SUPPLEMENT TO SPECIAL PROVISION NO. 907-618-1

DATE: 05/05/2009

PROJECT: MP-3000-00(055) / 303663301 -- Districtwide 3

After the first paragraph of Subsection 907-618.01.2 on page 1, add the following:

JEFFERSON COUNTY - HIGHWAY 553

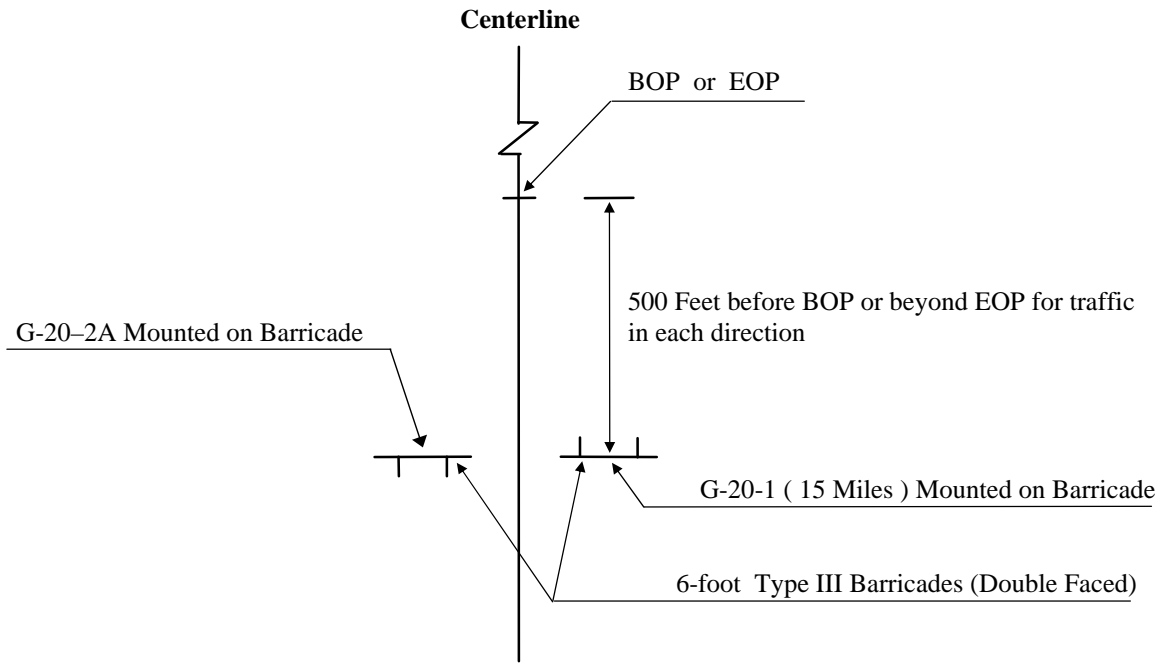
- 31 - W20-1 (AHEAD) signs required. One (1) W20-1 (AHEAD) sign is required at each local road or street entering the project.
- 225 - R4 -1 "DO NOT PASS" signs required.
- 30 - R4 -2 "PASS WITH CARE" signs required.
- 32 - W14 -3 "NO PASSING ZONE" signs required.

R4 -1 " DO NOT PASS ", R4 -2 " PASS WITH CARE" , and W14 -3 "NO PASSING ZONE" signs are required in accordance with Subsection 618.03.3, attached drawing, and as specified in the Manual on Uniform Traffic Control Devices. If no passing zones are 1,000 feet or more, install additional "DO NOT PASS" signs per attached drawing.

JEFFERSON COUNTY - HIGHWAY 552 – SITE 1

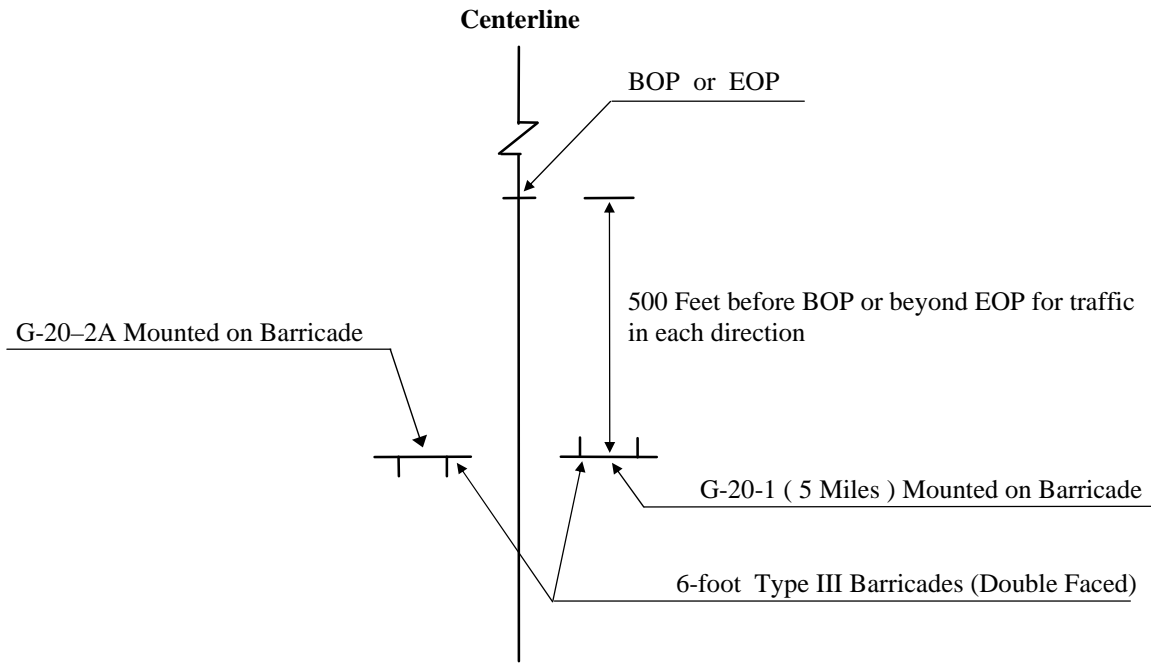
- 22 - W20-1 (AHEAD) signs required. One (1) W20-1 (AHEAD) sign is required at each local road or street entering the project.
- 175 - R4 -1 “DO NOT PASS” signs required.
- 26 - R4 -2 “PASS WITH CARE” signs required.
- 28 - W14 -3 “NO PASSING ZONE” signs required.

R4 -1 “ DO NOT PASS ”, R4 -2 “ PASS WITH CARE” , and W14 -3 “NO PASSING ZONE” signs are required in accordance with Subsection 618.03.3, attached drawing, and as specified in the Manual on Uniform Traffic Control Devices. If no passing zones are 1,000 feet or more, install additional “DO NOT PASS” signs per attached drawing.

JEFFERSON COUNTY - HIGHWAY 552 – SITE 2

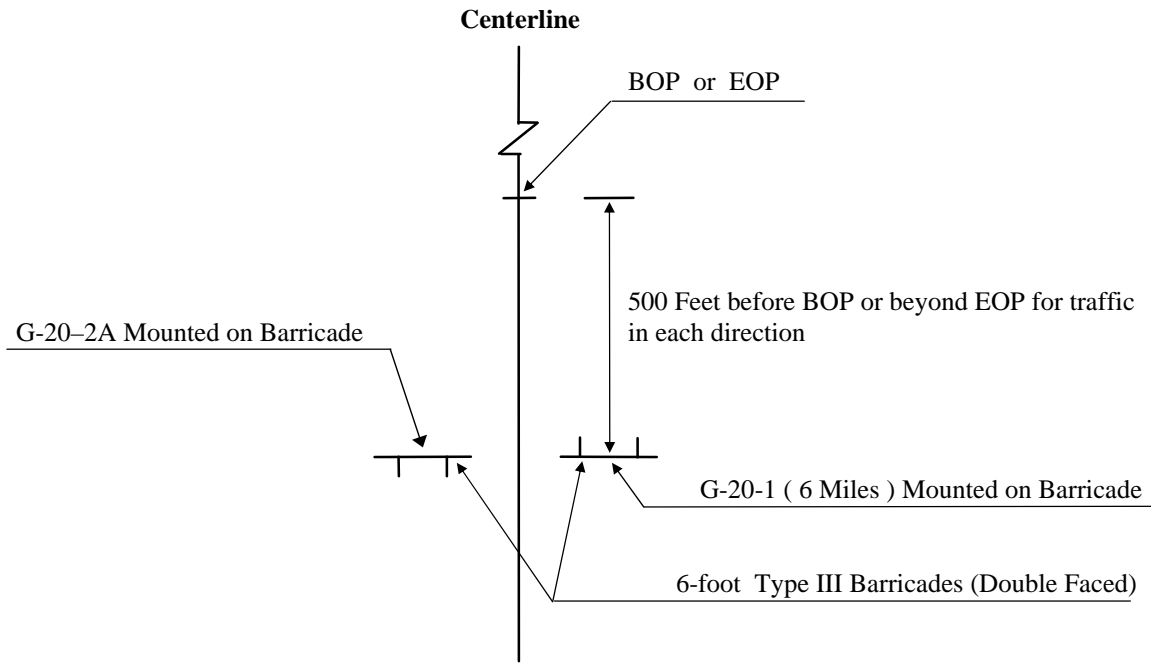
- 6 - W20-1 (AHEAD) signs required. One (1) W20-1 (AHEAD) sign is required at each local road or street entering the project.
- 56 - R4 -1 “DO NOT PASS” signs required.
- 6 - R4 -2 “PASS WITH CARE” signs required.
- 8 - W14 -3 “NO PASSING ZONE” signs required.

R4 -1 “ DO NOT PASS ”, R4 -2 “ PASS WITH CARE ” , and W14 -3 “NO PASSING ZONE” signs are required in accordance with Subsection 618.03.3, attached drawing, and as specified in the Manual on Uniform Traffic Control Devices. If no passing zones are 1,000 feet or more, install additional “DO NOT PASS” signs per attached drawing.

CLAIBORNE COUNTY - HIGHWAY 548

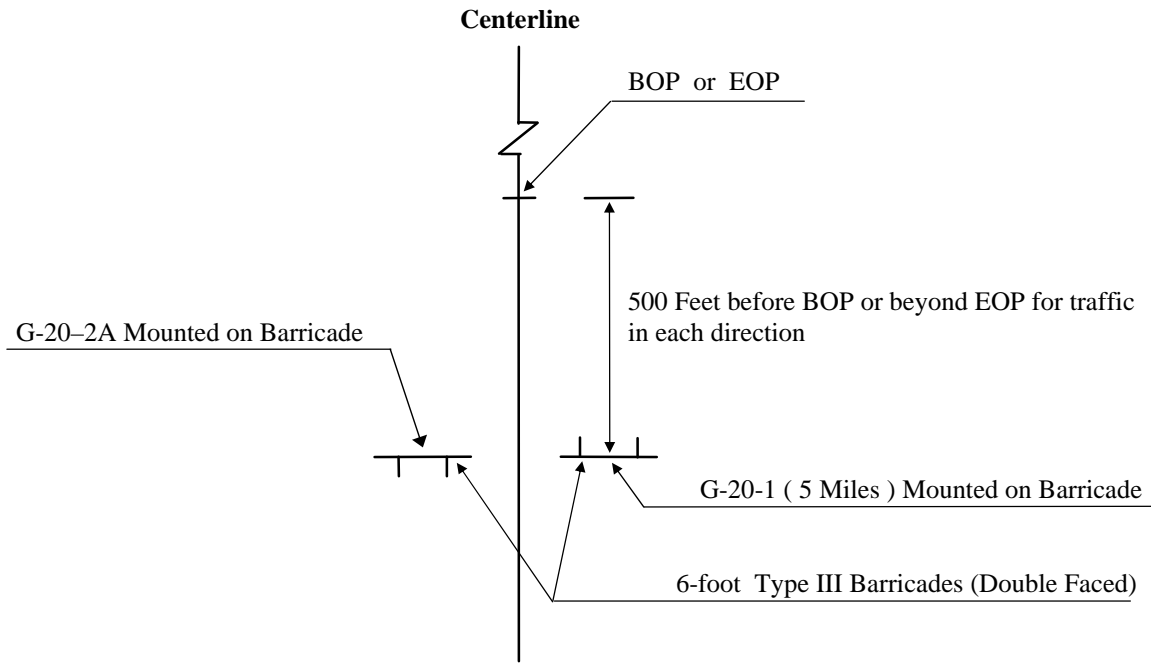
- 10 - W20-1 (AHEAD) signs required. One (1) W20-1 (AHEAD) sign is required at each local road or street entering the project.
- 69 - R4 -1 “DO NOT PASS” signs required.
- 8 - R4 -2 “PASS WITH CARE” signs required.
- 10 - W14 -3 “NO PASSING ZONE” signs required.

R4 -1 “ DO NOT PASS ”, R4 -2 “ PASS WITH CARE ”, and W14 -3 “NO PASSING ZONE” signs are required in accordance with Subsection 618.03.3, attached drawing, and as specified in the Manual on Uniform Traffic Control Devices. If no passing zones are 1,000 feet or more, install additional “DO NOT PASS” signs per attached drawing.

CLAIBORNE COUNTY - HIGHWAY 462

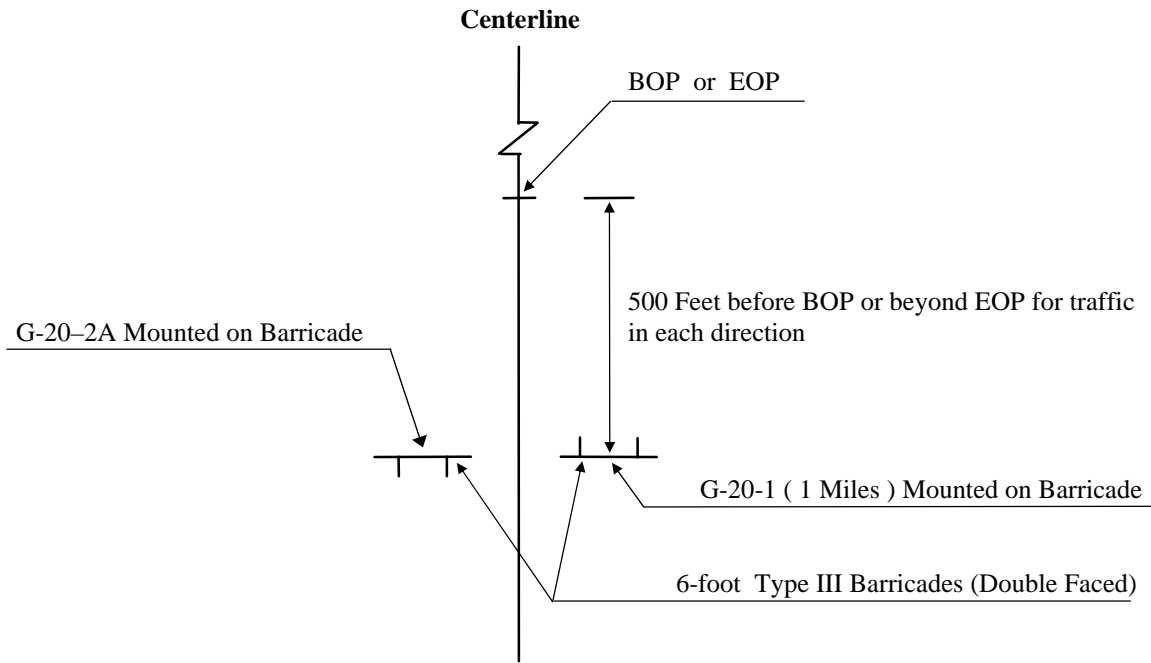
- 3 - W20-1 (AHEAD) signs required. One (1) W20-1 (AHEAD) sign is required at each local road or street entering the project.
- 66 - R4 -1 "DO NOT PASS" signs required.
- R4 -2 "PASS WITH CARE" signs required.
- 2 - W14 -3 "NO PASSING ZONE" signs required.

R4 -1 " DO NOT PASS ", R4 -2 " PASS WITH CARE" , and W14 -3 "NO PASSING ZONE" signs are required in accordance with Subsection 618.03.3, attached drawing, and as specified in the Manual on Uniform Traffic Control Devices. If no passing zones are 1,000 feet or more, install additional "DO NOT PASS" signs per attached drawing.

CLAIBORNE COUNTY - HIGHWAY 552 - SITE 1

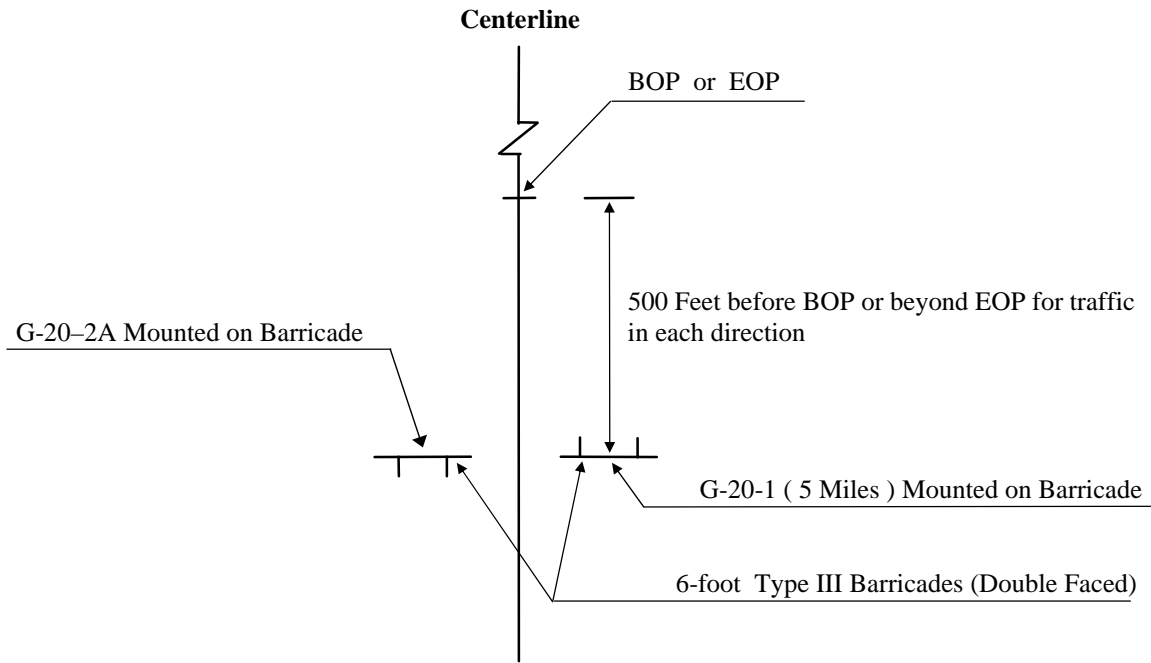
- - W20-1 (AHEAD) signs required. One (1) W20-1 (AHEAD) sign is required at each local road or street entering the project.
- 4 - R4 -1 “DO NOT PASS” signs required.
- 2 - R4 -2 “PASS WITH CARE” signs required.
- 4 - W14 -3 “NO PASSING ZONE” signs required.

R4 -1 “ DO NOT PASS ”, R4 -2 “ PASS WITH CARE” , and W14 -3 “NO PASSING ZONE” signs are required in accordance with Subsection 618.03.3, attached drawing, and as specified in the Manual on Uniform Traffic Control Devices. If no passing zones are 1,000 feet or more, install additional “DO NOT PASS” signs per attached drawing.

CLAIBORNE COUNTY - HIGHWAY 552 - SITE 2

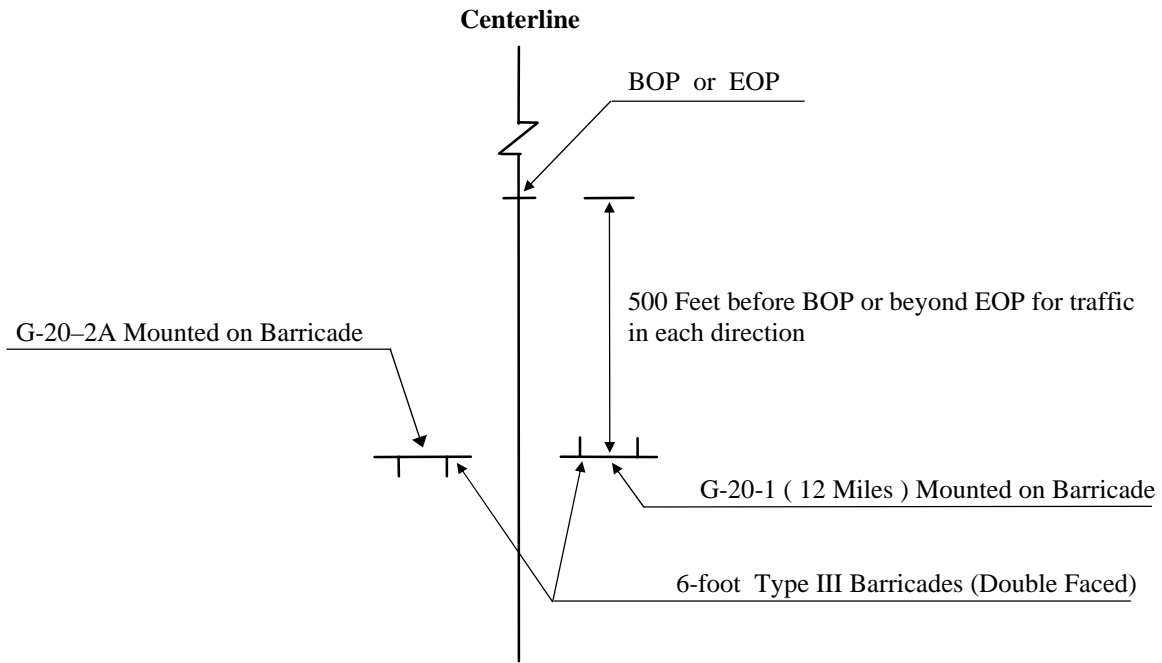
- 5 - W20-1 (AHEAD) signs required. One (1) W20-1 (AHEAD) sign is required at each local road or street entering the project.
- 40 - R4 -1 "DO NOT PASS" signs required.
- 4 - R4 -2 "PASS WITH CARE" signs required.
- 6 - W14 -3 "NO PASSING ZONE" signs required.

R4 -1 " DO NOT PASS ", R4 -2 " PASS WITH CARE" , and W14 -3 "NO PASSING ZONE" signs are required in accordance with Subsection 618.03.3, attached drawing, and as specified in the Manual on Uniform Traffic Control Devices. If no passing zones are 1,000 feet or more, install additional "DO NOT PASS" signs per attached drawing.

CLAIBORNE COUNTY - HIGHWAY 547

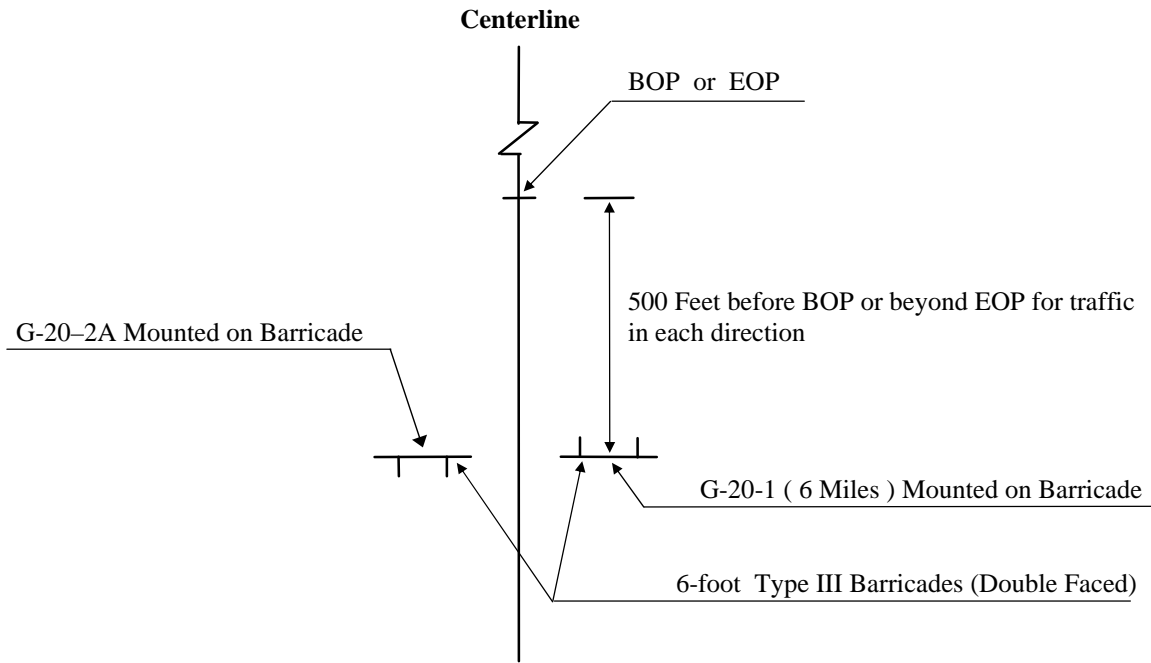
- 15 - W20-1 (AHEAD) signs required. One (1) W20-1 (AHEAD) sign is required at each local road or street entering the project.
- 94 - R4 -1 "DO NOT PASS" signs required.
- 29 - R4 -2 "PASS WITH CARE" signs required.
- 29 - W14 -3 "NO PASSING ZONE" signs required.

R4 -1 " DO NOT PASS ", R4 -2 " PASS WITH CARE" , and W14 -3 "NO PASSING ZONE" signs are required in accordance with Subsection 618.03.3, attached drawing, and as specified in the Manual on Uniform Traffic Control Devices. If no passing zones are 1,000 feet or more, install additional "DO NOT PASS" signs per attached drawing.

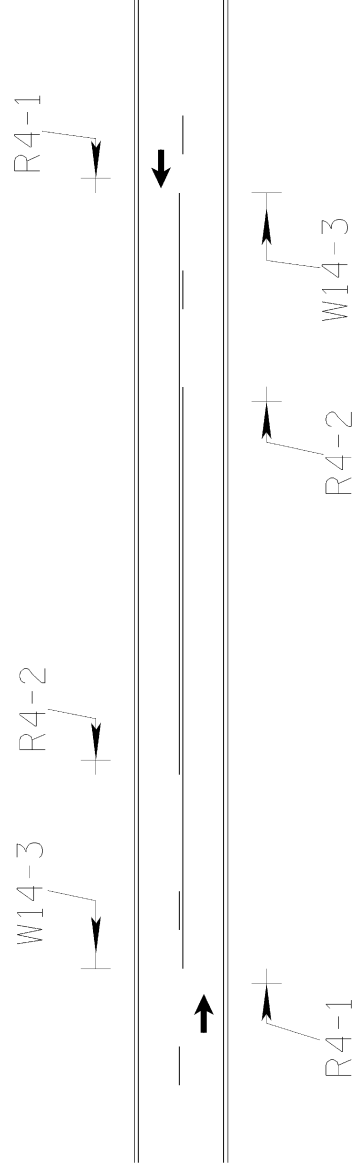
- ① THE R4-1, DO NOT PASS SIGNS, SHALL BE PLACED ON THE RIGHT SIDE OF THE ROAD AT THE BEGINNING OF THE NO PASSING ZONE. ADDITIONAL R4-1 SIGNS SHALL BE PLACED ON THE RIGHT IN INCREMENTS OF 750' TO 1000' THROUGHOUT THE LENGTH OF THE NO PASSING ZONE.
- ② THE R4-2, PASS WITH CARE SIGN, SHALL BE PLACED ON THE RIGHT SIDE OF THE ROAD AT THE END OF THE NO PASSING ZONE.
- ③ THE W4-3, NO PASSING ZONE SIGN, SHALL BE PLACED ON THE LEFT SIDE OF THE ROAD AT THE BEGINNING OF EACH NO PASSING ZONE. THE CONTRACTOR MAY BE REQUIRED TO PLACE W4-3 SIGNS ON THE LEFT IN INCREMENTS OF 750' TO 1000' THROUGHOUT THE NO PASSING ZONE. THE QUANTITY FOR W4-3 SIGNS WILL INDICATE IF THESE SIGNS ARE REQUIRED.
- ④ THE R4-1, R4-2 AND W4-3 SIGNS ARE TO BE USED WHEN STANDARD PAVEMENT MARKINGS ARE NOT IN PLACE. SIGNS MAY ALSO BE USED TO EMPHASIZE PAVEMENT MARKINGS.
